# Relaying a TM Correction

I have a problem with Figure 15 on Pages C-42 and C-43 in the 3-KW TQG technical manual, TM 9-6115-639-13&P (15 Aug 2005). The drawing and the parts list shows all three electromagnetic relays as identical.

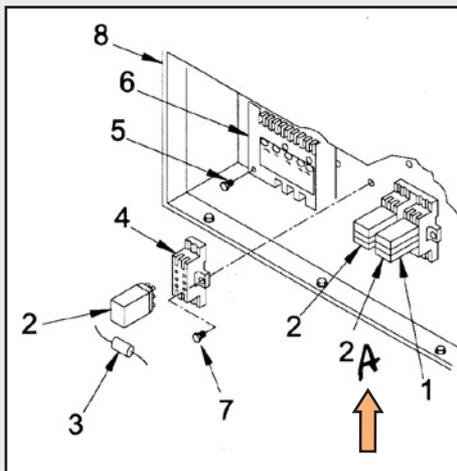
The first two relays are 24 VDC and the last relay is 110-120 VAC. If a soldier plugs a 24 VDC relay into the socket meant for a 110-120 VAC relay, when the generator is started, the relay coil will burn up!

The TM is wrong for the 60 Hz model of the generator. (It's right for the 400 Hz model.) 60 Hz, 3-KW TQG maintainers, get out your stubby pencil and make these changes in TM 9-6115-639-13&P. (If you're using an electronic TM, print the pages and make the changes, then keep those pages with the electronic manual disk.)

Make your first change to Figure 15 on page C-42. The figure has three 2's, each one pointing to a relay. Make the 2 on the far right relay, a 2A.

Now, go to the next page and the parts list. On Item 2, change the quantity from 3 to 2. Now, add an Item 2A. Here's how the addition should look:

Item	SMR	NSN	CAGE	PART NUMBER	DESCRIPTION, (UOC)	QTY
2A	PAOZZ	5945-01-558-5373	60886	RH2B-ULAC-110-120V	Relay, Electromagnetic 60 Hz, UOC: LQQ	1

Now look at Item 3 in that list—the semiconductor device. Add to the item description 60 Hz and a UOC of LQQ. Change the quantity from 1 to 2. Also, note that although this part is still in stock, it is obsolete and you may have a semiconductor device with a part number of 1.5KE51CA instead of the one listed.
